30 January 2019

Submission on the Waterloo Metro Quarter Over Station Development – Reference SSD 18_9393

Fig 1: Street wall alignment (Courtesy of Turner and Turf)

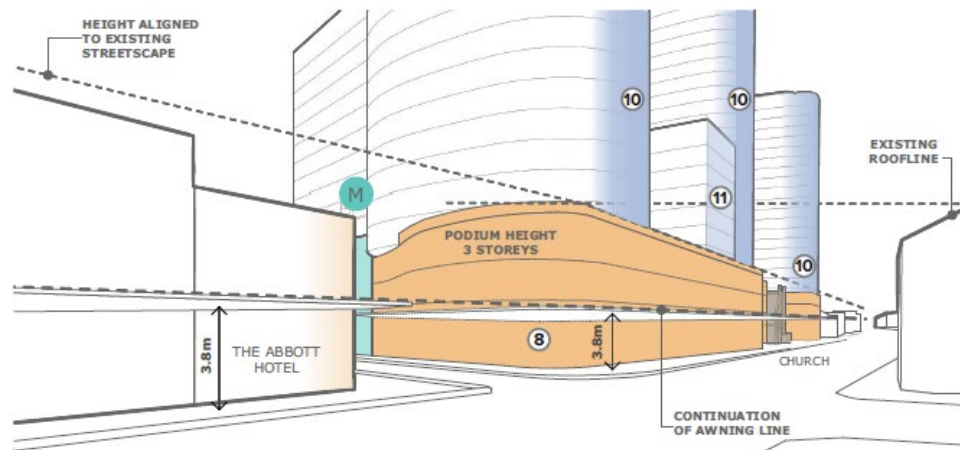
We support the proposed podium height along Botany Road which aligns with the predominant street wall height and the heritage item on site (Figure 1). This will establish a consistent streetscape along Botany Road. Issues of concern regarding the Podium North articulations are raised during our review. We note that a service entry and a single storey pedestrian link are proposed on the street level along Botany Road; however, no further articulations are provided on the levels above according to the architectural drawings. The podium should articulate more considering it is over 100m in length measured from Raglan Street façade to the proposed pedestrian link (Figure 2). A well-articulated podium form will provide a human-scale environment and will provide a more sympathetic approach to the surrounding Heritage Conservation Areas (HCA).

Fig 3: Wellington Street street pattern (Adapted from Turner and Turf)

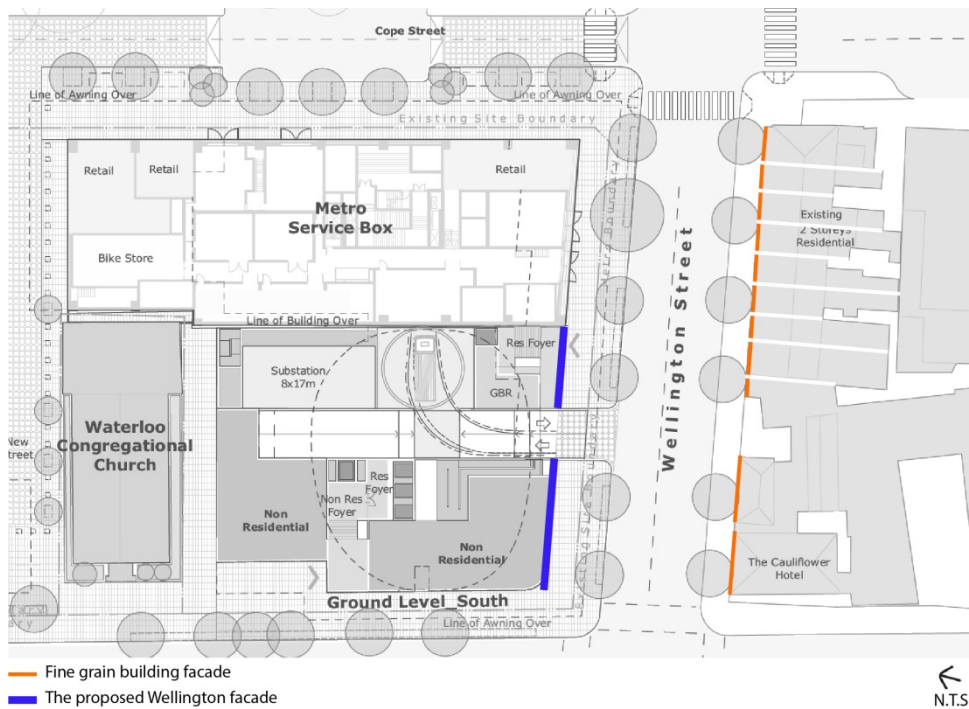
Built form articulation on Podium South facing Wellington Street should also be considered to reflect the fine grain pattern and the heritage listed item – Cauliflower Hotel on the other side of the street (Figure 3 and 4).

Fig 5: The proposed towers and skyline (Adapted from Turner and Turf)

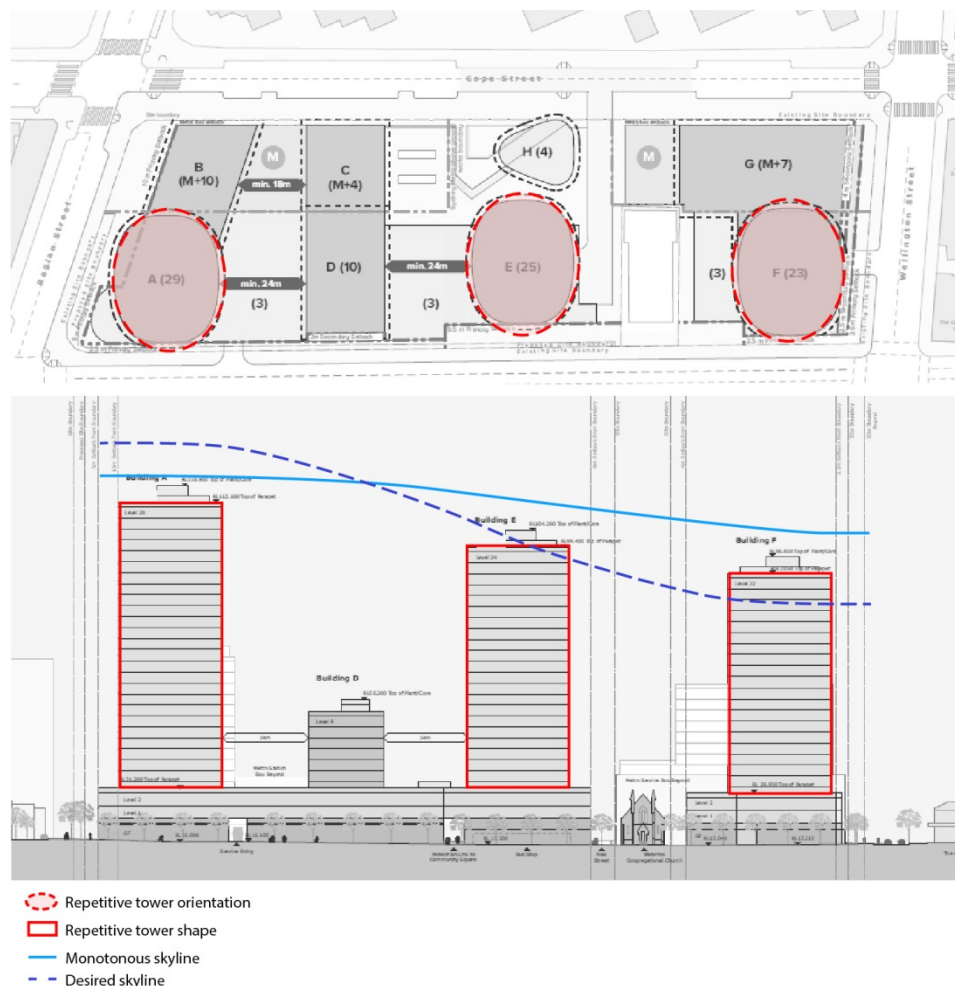
Three towers are proposed within the site with similar shape and same orientation. The height differences among the three towers are minimal, which creates a rather repetitive build form and a monotonous skyline (Figure 5). This will provide a less interesting urban environment and will contribute to the proposal's overall bulk and scale. An alternative design approach should be considered, which may include orienting the middle tower north-south, transforming some of the tower height from Building F to Building A, and providing different façade articulations among the three towers. This will break down the proposal into smaller scaled development parcels with differing character.

Fig 6: The proposal's response to Raglan Street streetscape (Adapted from Turner and Turf)

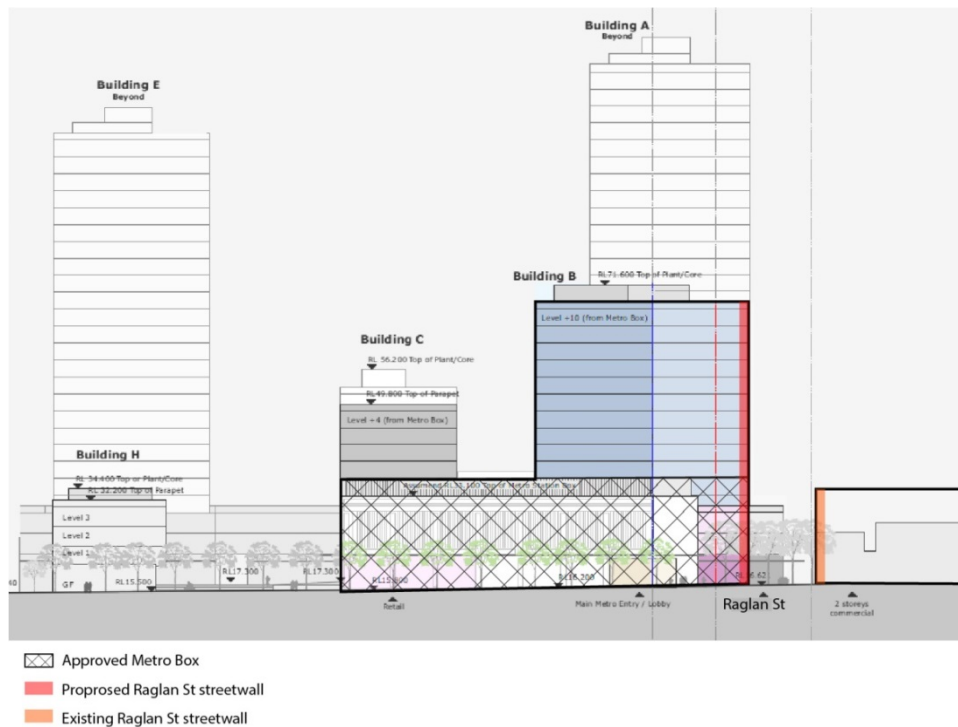
The proposed Raglan Street elevation appears to be bulky and out of context. An approximately 15st built form (Building B together with the Metro Box) is proposed without any secondary setbacks. A setback for the built form above the Metro Box will emphasise the established 3-4 storey street wall height and will provide a more human-scale streetscape along Raglan Street (Figure 6). Further articulation should also be introduced between the tower forms and the build forms connected to them to distinguish the towers more and reduce the overall bulk (Figure 7).

Fig 10: Cope Street interface (Adapted from Turner and Turf)

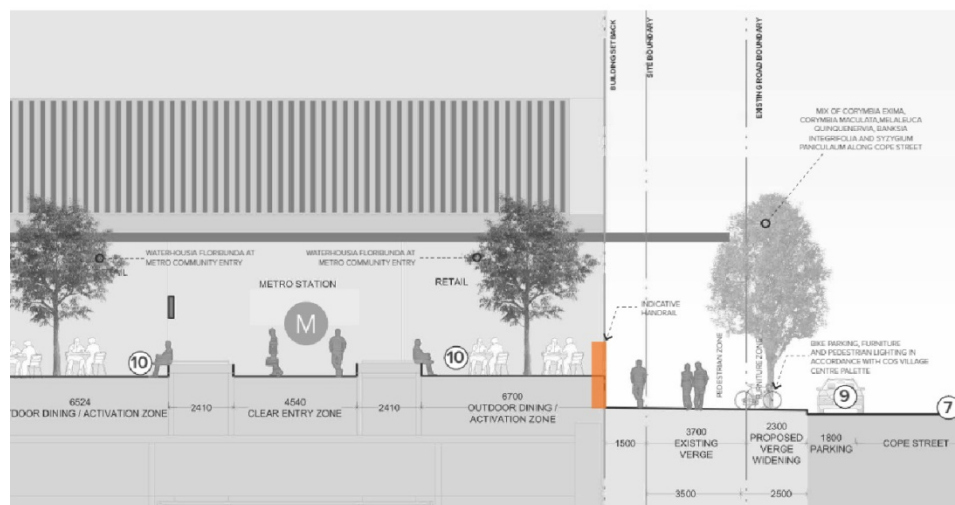
The proposed Community Square's amenity and useability is further affected by the undercroft area under Building H and Building E's columns onto the footpath. We note that an elevated lawn is provided along Cope Street within the future Community Square. The raised lawn will limit the pedestrian access to the public domain and will create a retaining wall facing the Cope Street footpath (Figure 10). The design should minimise the impacts on the pedestrian movements by removing the obstacles and providing a clear circulation. The St. Margarets development in Surry Hills sets a good example where clear and accessible pedestrian circulations and open spaces are provided with good level of solar access (Figure 8 and 9).

Elevated lawn limiting pedestrian access and creating a retaining wall facing the Cope St footpath

Fig 11: The setback to the church creating a left over space (Adapted from Turner and Turf)

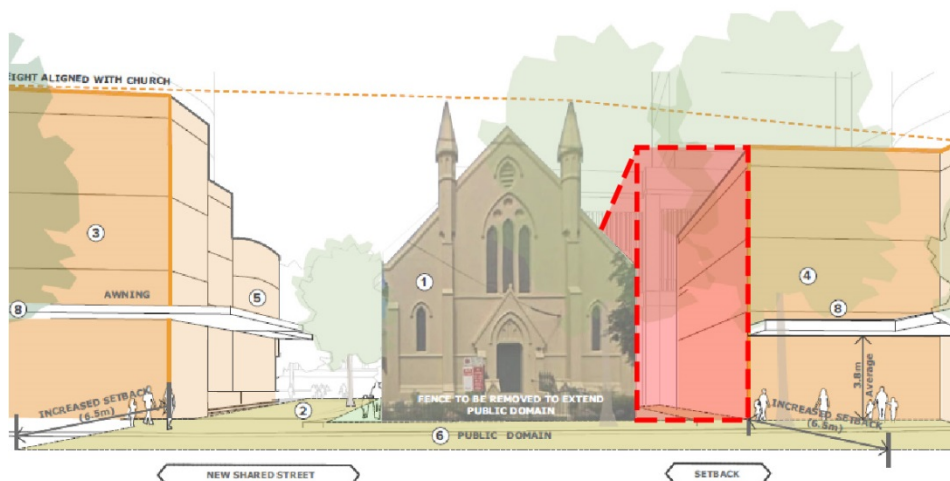
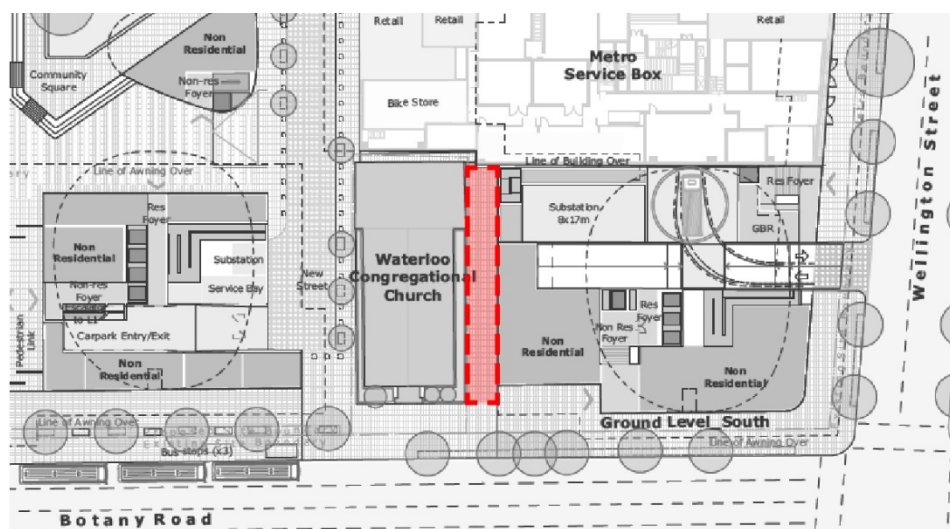
The idea of providing setbacks to the heritage item – Waterloo Congregational Church is supported. The proposal provides a good response to the heritage item by providing height and street frontage alignments. It is our concern that the public open space created by the setback from the Podium South to the church will form a left over space, as it lacks ground floor activation and creates a dead end at its eastern end (Figure 11). This space can be improved by providing retail shops with outdoor sitting areas or dedicate the area to the church to form its gathering space.

Space lacks activation

Fig 12: Unit layout should be redesigned (Adapted from Turner and Turf)

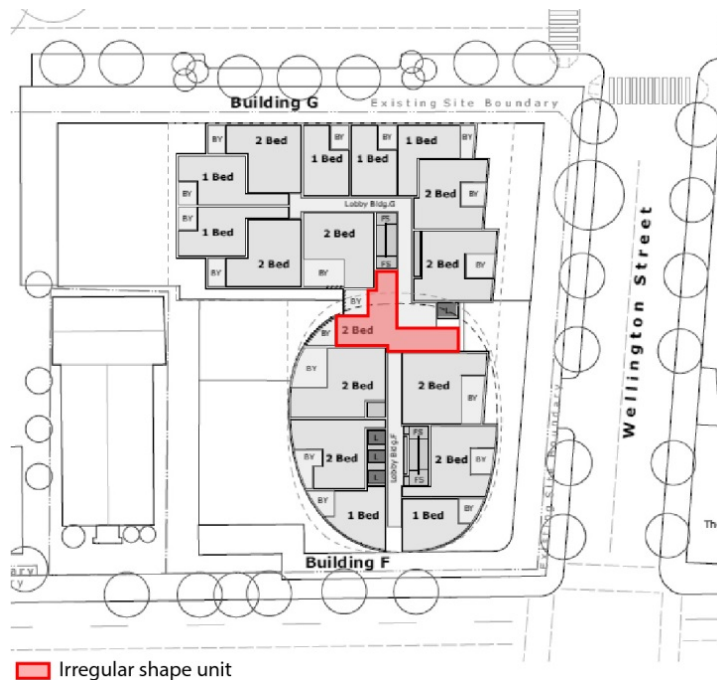
The residential amenity is also determined by the apartment layouts. An efficient layout which maximises the usable floor space is desired. There are some units within Building G (2-bedroom apartments near the lift core) appear to have irregular shape with multiple corners (Figure 12). The abovementioned units should be reconfigured to have a more efficient layout.
